CLIENT	Fortis Development Group
JOB	1728 Fortis South Steyne 34-35 South Steyne Manly NSW

PROJECT NO.	ISSUE	REV.
1728	S4.55	DA-L
DRAWING NO.		
A-DA-110-000

CHANGES RELEVANT TO THIS MODIFICATION APPLICATION

TITLE
GA Sections
Section AA, BB & EE

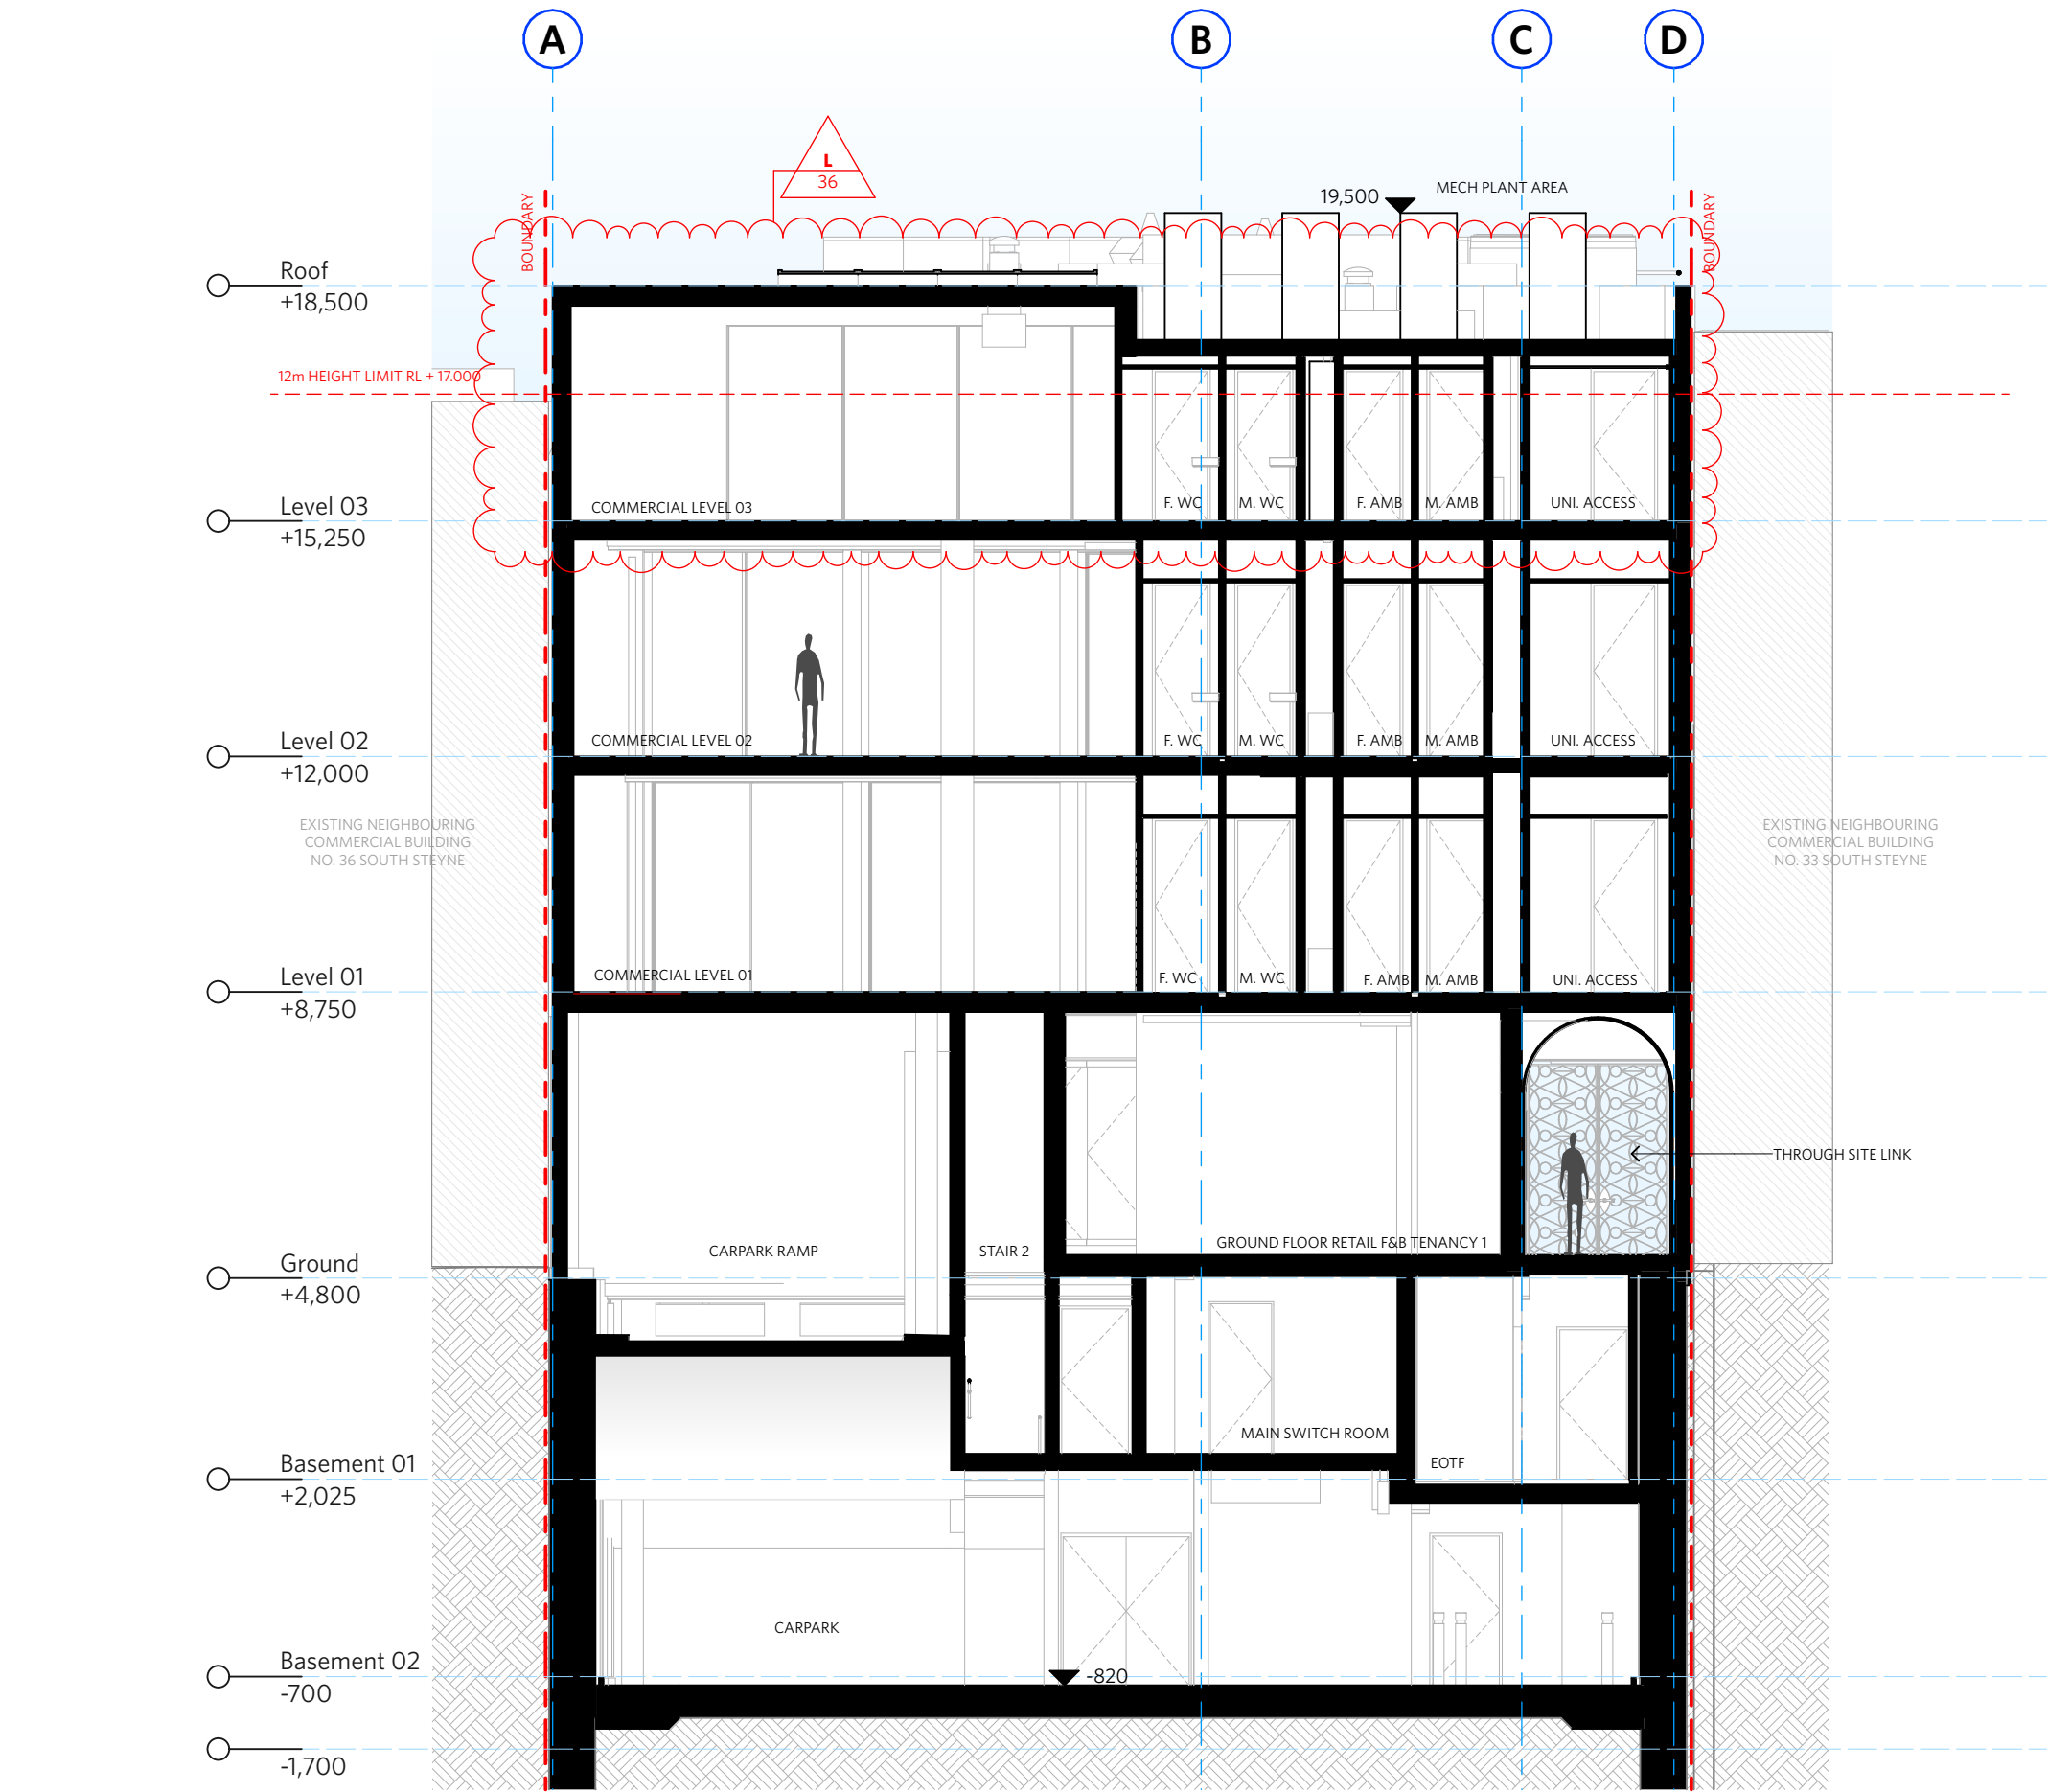
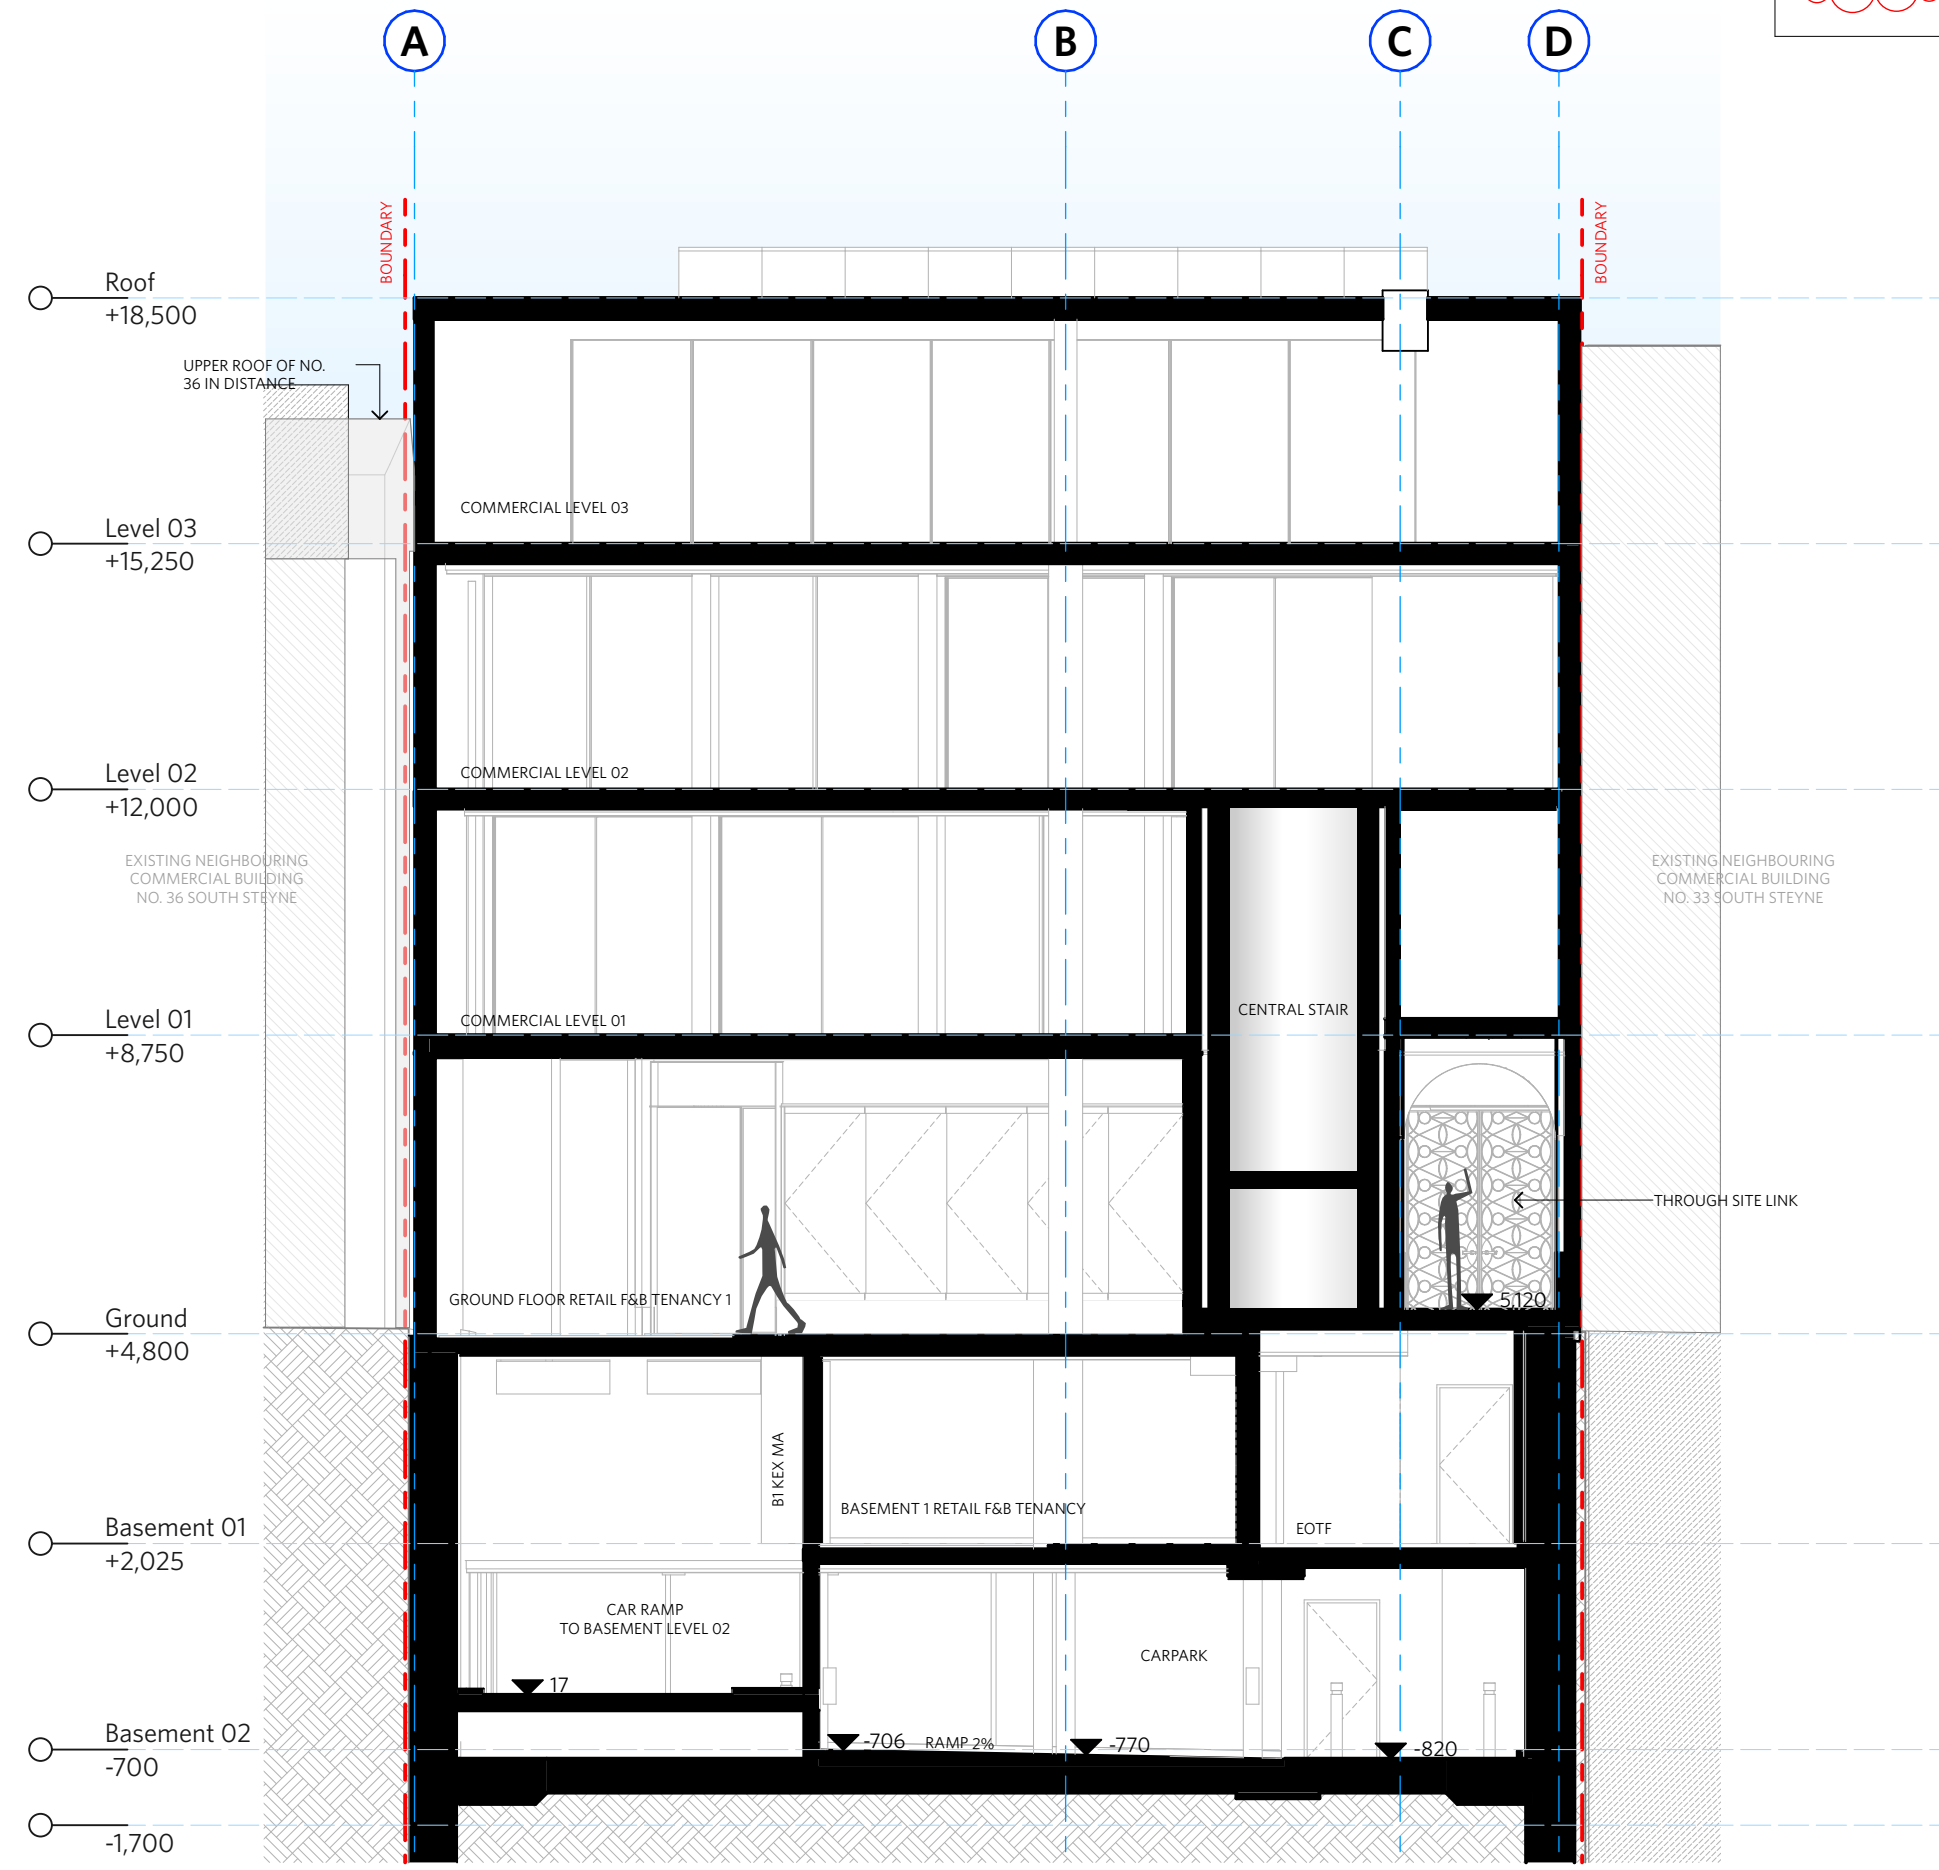
REV	CHANGE	DESCRIPTION
DA-L	36	Change of Layout to Level 03 Floor
